PlanGrid Task Report - Sep 9, 2024

13 tasks in this report.

#466 [UNIT 999] - RTU Alarms Present

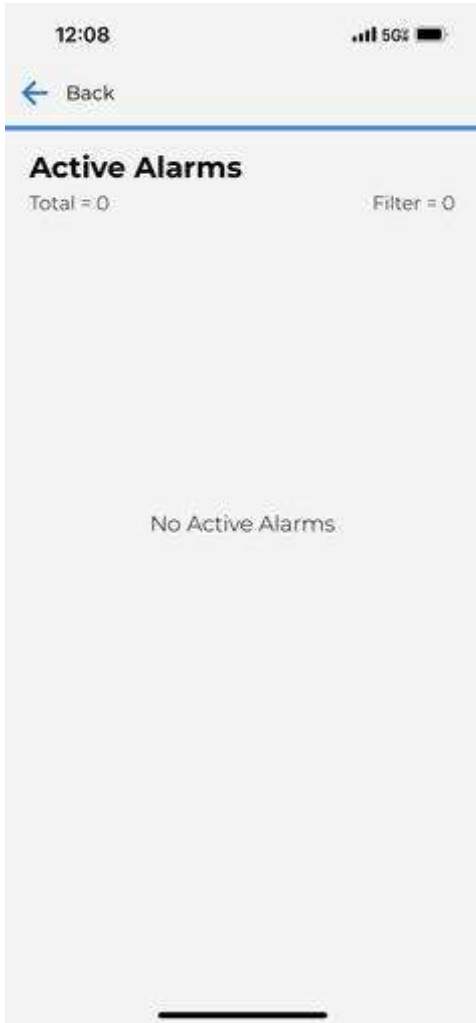
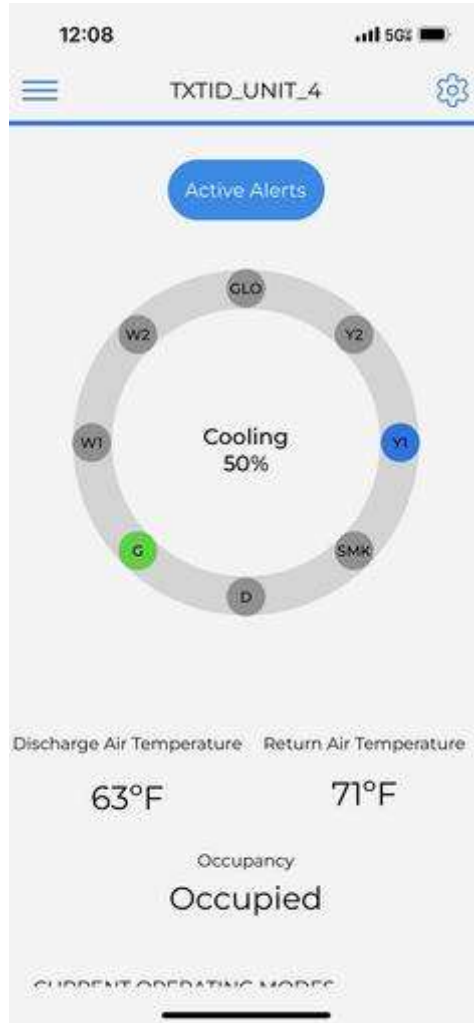
The following alarms were found on the RTUs:
RTU 3 - Alarm 147 & 137

No active alarms on RTU's 1,3,4

RTU #3 alarming 137 & 147. Economizer functioning correctly and at NTi setpoint.

Sheet
M1.1

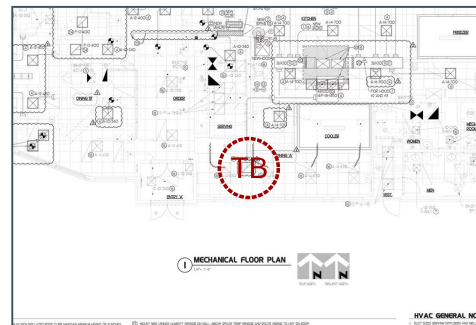
Description
Return Grille 2-1 could not be located in the space. Per M1.1 it should be located adjacent to diffusers 1-1 and 1-2 (side dining area).
*Reference NTi GRD Layout.

No change

NTi diffuser balance satisfies RFI #2 as-is. No changes required.

Satisfies RFI 11 Issue #2

Sheet
M4.2

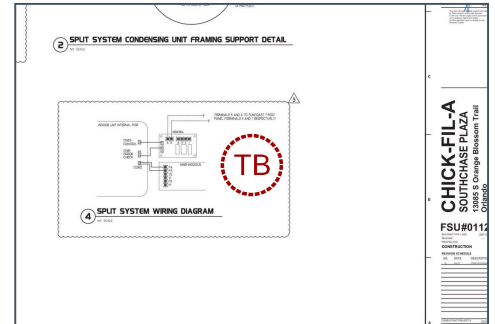
Description
Mini split control wires not landed in suncoast panel.

No wires landed 6/19

No wires landed 9/9

#412 [CNTL 508] [NEW] Controls labeling.

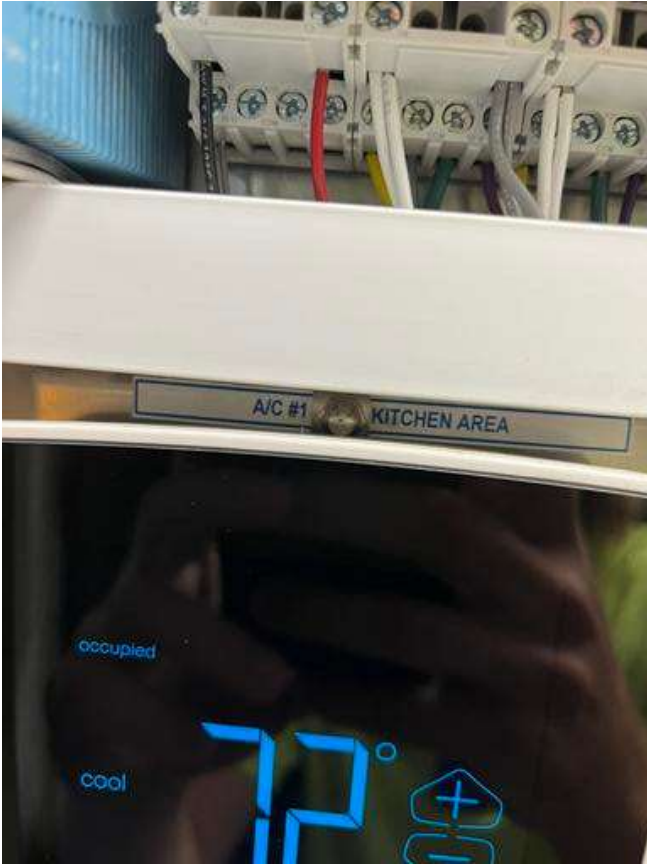
Label all sensors, humidistats, thermostats, smoke annunciators and remote space mounted OADs, MODs, VFD's for which piece of equipment they serve. Remote sensors labeled incorrectly (wrong units). Thermostats 1 and 2 labeled incorrectly (switch labels).

All sensors are now labeled but the label numbering does not match the mechanical plans. Per the mechanical plans: RTU 1 - Side Dining, RTU 2 - Kitchen, RTU 3 - Dining "B", RTU 4 - Dining "B" (where playroom previously existed).

Thermostat labeling not corrected. RTU 1 serves the side dining and RTU 2 serves the kitchen, per the mechanical plans.

See above comments. Sensors are labeled, but labeling does not match the mechanical plans.
